BEAL EARLY CHILDHOOD CENTER  
1 Maple Avenue  
Shrewsbury, MA 01545

PROJECT: TOWN OF SHREWSBURY ACCESSIBILITY PROJECT  
DRAWING: BEAL EARLY CHILDHOOD CENTER  
SCALE: 1" = 20'-0"  
DATE: FEBRUARY 2002

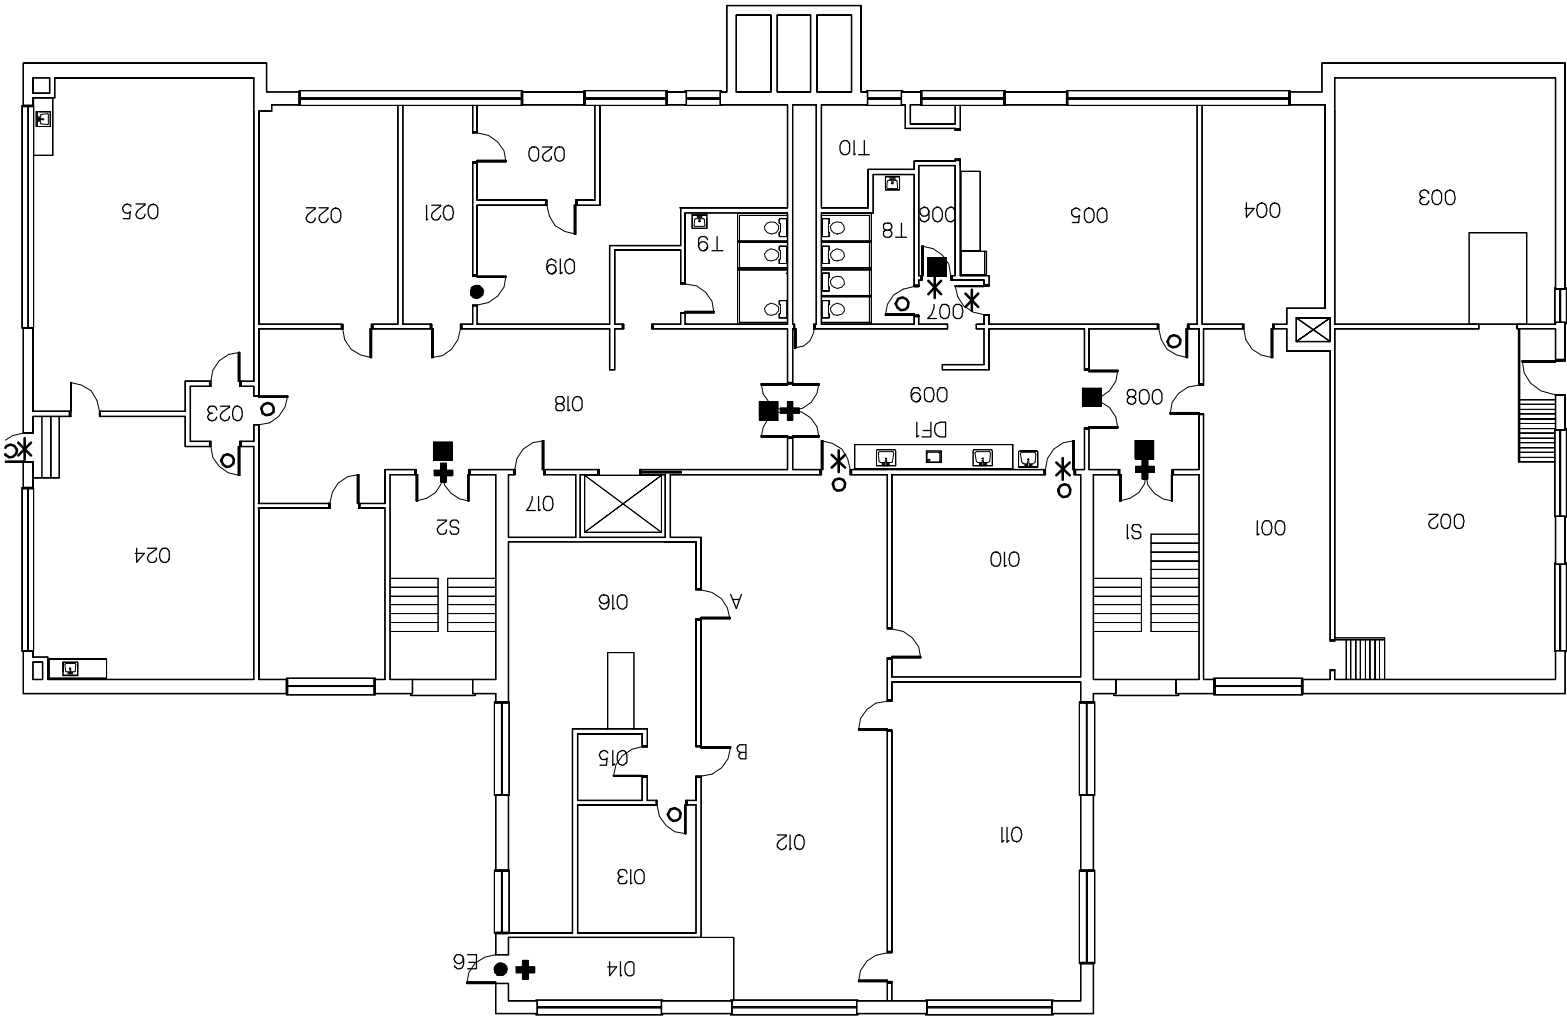
<i>Item</i>	<i>Action Required</i>	<i>Est. Cost</i>	<i>Priority</i>	<i>Feasibility</i>
1 single door does not have a 32" clear opening.	Widen door.	800	2	2
10 pairs of doors do not a 32" clear opening.	Replace with different sized leaves to create a 32" clear opening.	8,000	2	2
15 doors do not have the required clearances on the pull side.	Relocate door 012-009; T-10; The classroom doors should be altered as per attached sketch. All other non-conforming doors lead to non-accessible spaces or are not feasible to correct.	41,500	2	3
12 doors do not have the required clearance on push side	Door 012-009 is corrected above. Doors 024-023; 018-023; 013-016; should be moved sideways. Remove obstruction from the push side of doors 008-005 and 201-208. All other doors lead to non-accessible spaces or are not feasible to correct.	7,000	2	3
17 doors have hardware that is not operable with a closed fist.	Change to lever hardware.	3,400	2	2

19 doors have closers that close too fast or are too hard to operate.	Replace or adjust closers.	9,500	2	2

FIRST FLOOR PLAN

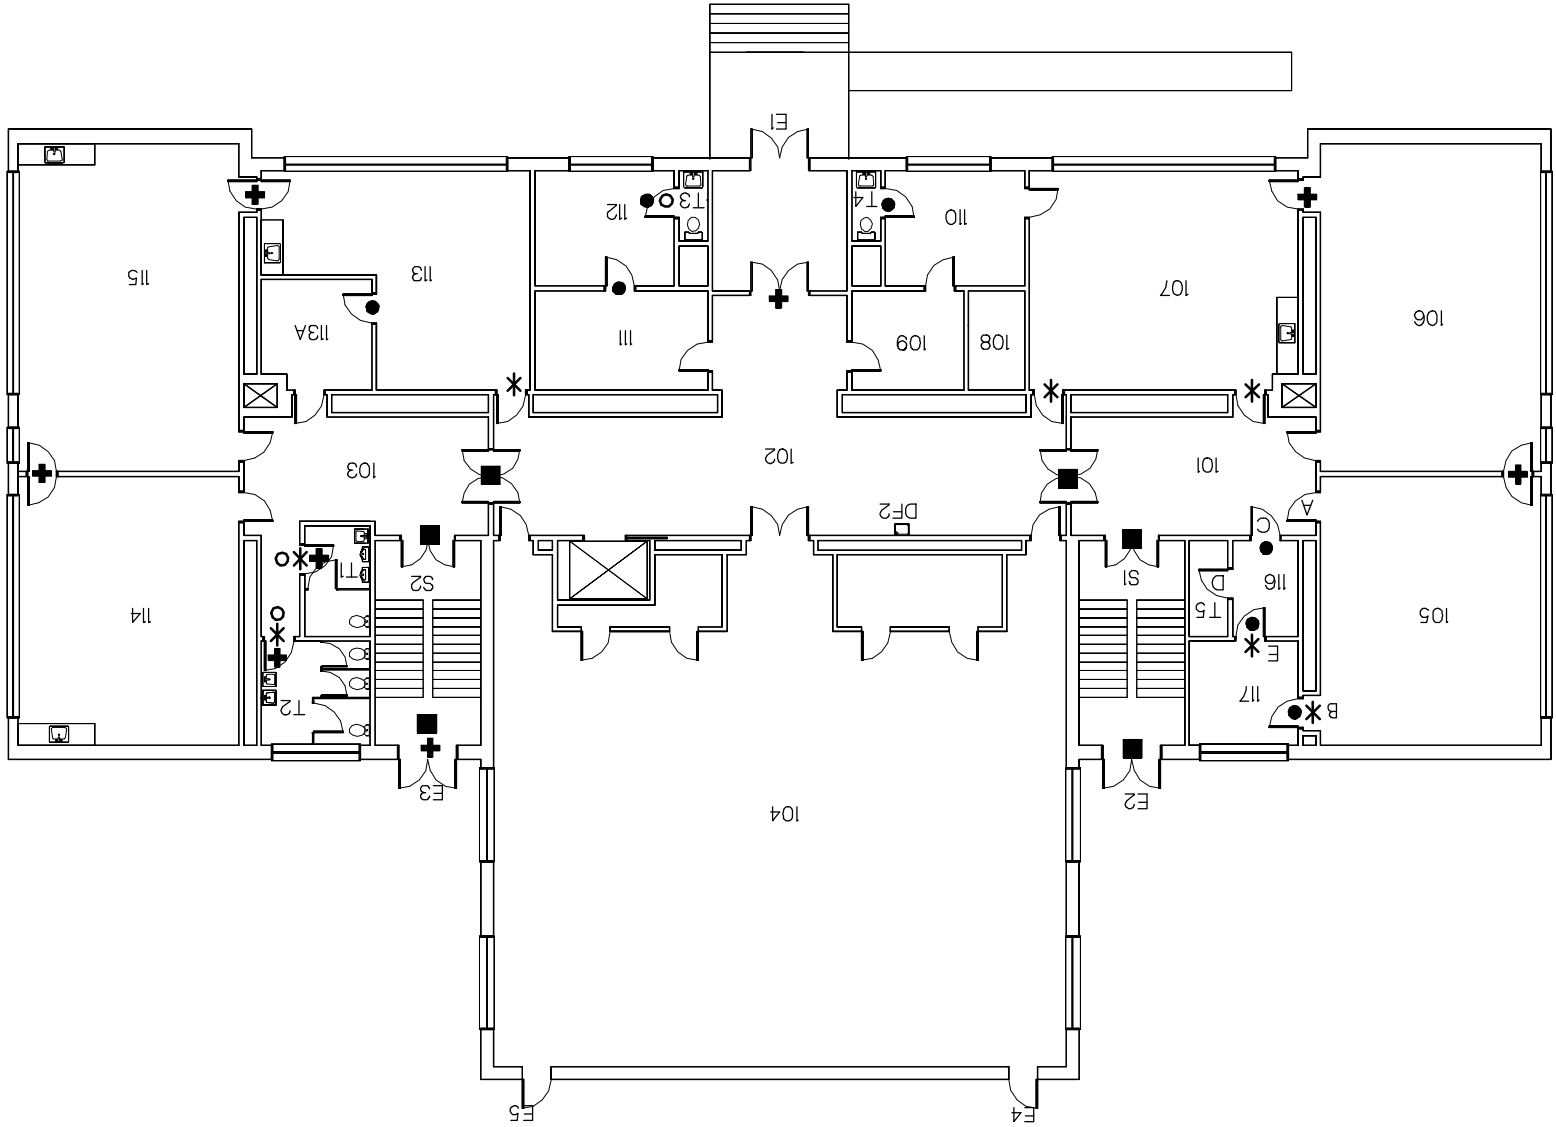
- LEGEND
- THE EXISTING DOOR OPENING IS LESS THAN THE REQUIRED 32" CLEAR.
  - \* THE EXISTING DOOR DOES NOT HAVE THE REQUIRED 18" PULL SIDE CLEARANCE.
  - THE EXISTING DOOR DOES NOT HAVE THE REQUIRED 12" PUSH SIDE CLEARANCE.
  - EXISTING HARDWARE DOES NOT MEET CURRENT MAAB GUIDELINES.
  - + EXISTING DOOR CLOSER DOES NOT MEET CURRENT MAAB GUIDELINES.

SECOND FLOOR PLAN

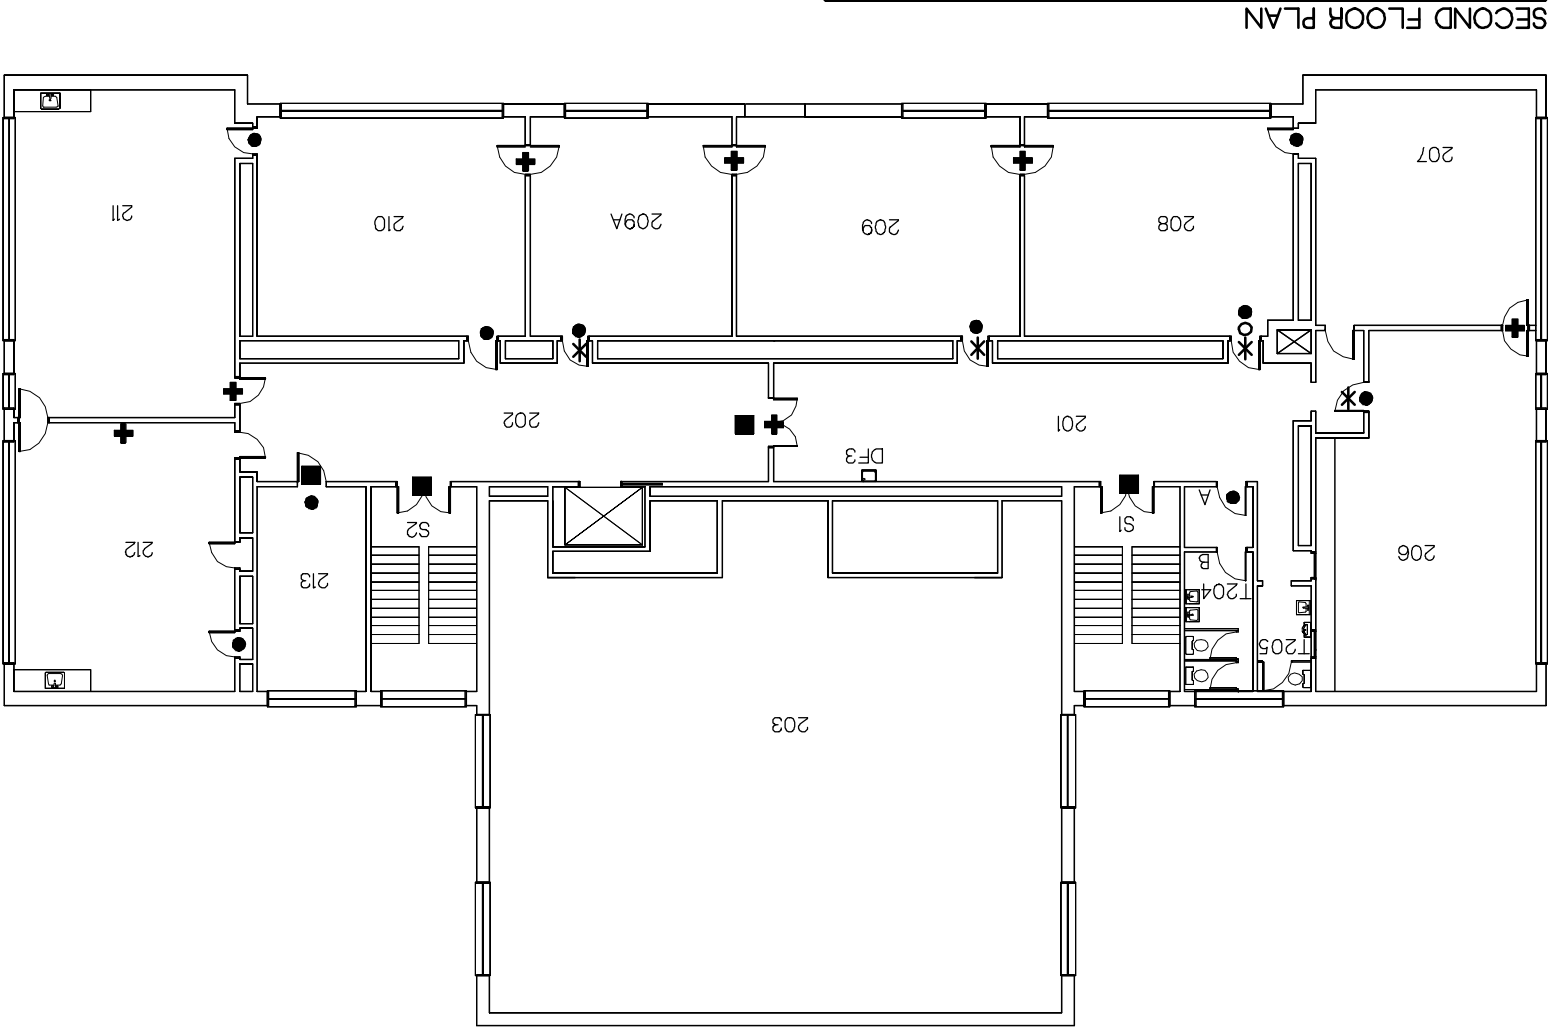
- LEGEND
- THE EXISTING DOOR OPENING IS LESS THAN THE REQUIRED 32" CLEAR.
  - \* THE EXISTING DOOR DOES NOT HAVE THE REQUIRED 18" PULL SIDE CLEARANCE.
  - THE EXISTING DOOR DOES NOT HAVE THE REQUIRED 12" PUSH SIDE CLEARANCE.
  - EXISTING HARDWARE DOES NOT MEET CURRENT MAAB GUIDELINES.
  - + EXISTING DOOR CLOSER DOES NOT MEET CURRENT MAAB GUIDELINES.
